IN THE DRAWINGS

REMARKS

FIG. 2
(PRIOR ART)

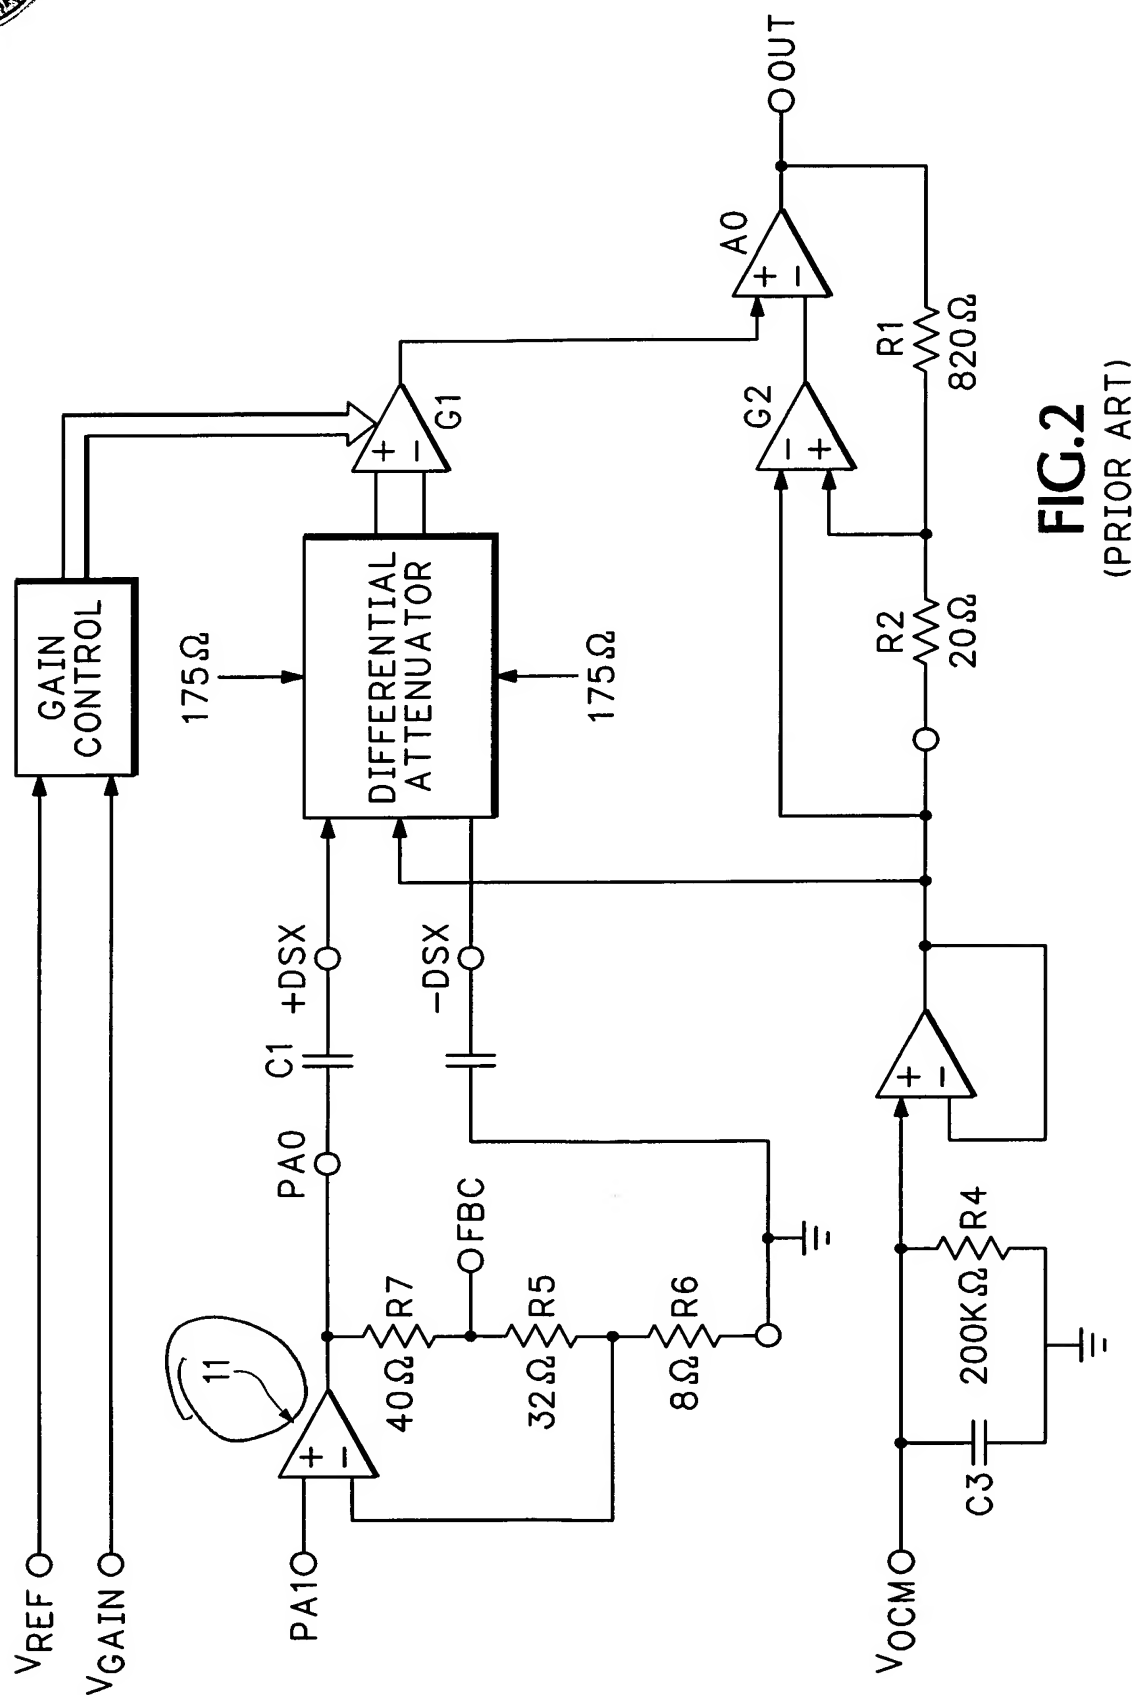
Figs. 2, 3, 4 and 5 are amended to correct errors and to conform to the specification. Replacement Sheets including amended Figs. 2, 3, 4 and 5 are included as attachments, as are Annotated Sheets showing in detail the changes made.

The drawings are amended to correct errors and to conform to the specification.

FIG.3
 (PRIOR ART)

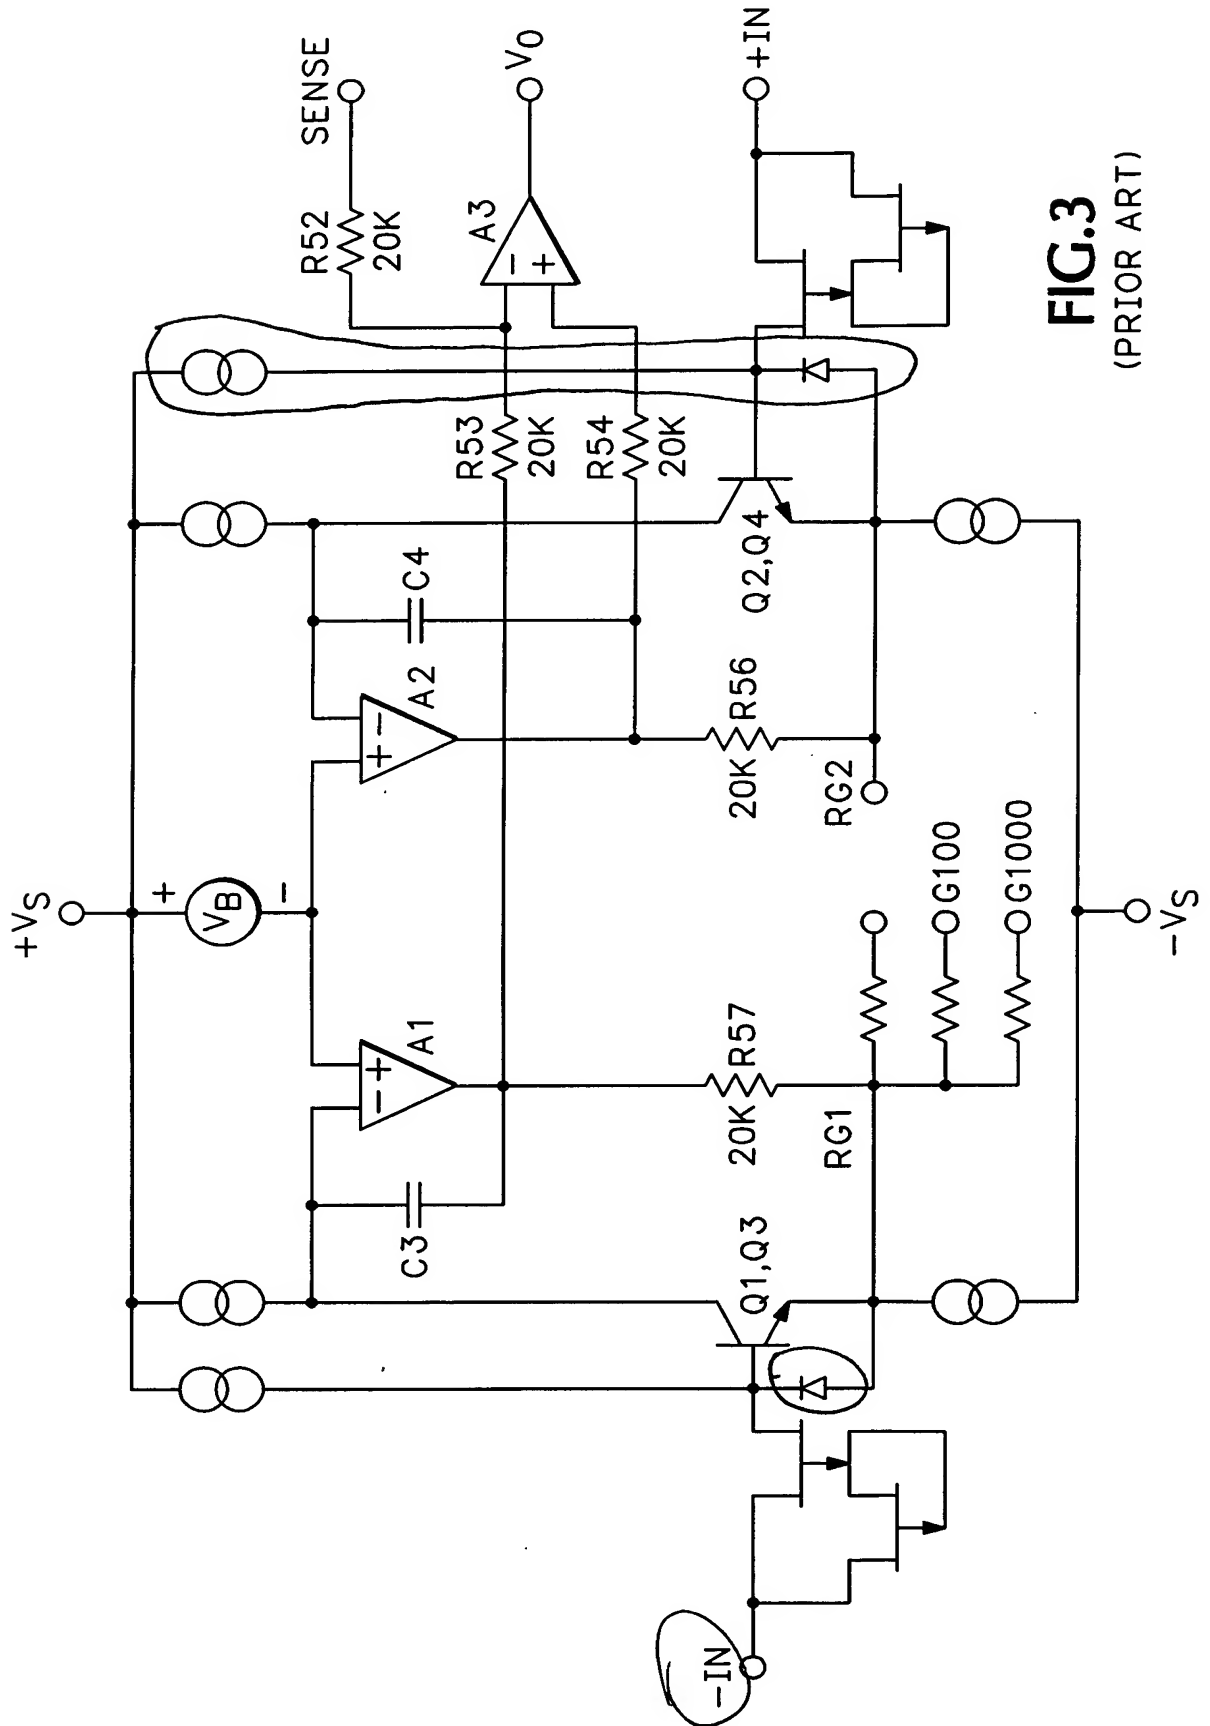
Claims 1, 3-5, 13 and 14 are rejected under 35 U.S.C. §102(b) as being anticipated by applicant's admitted prior art (Fig. 3). Applicant traverses this rejection.
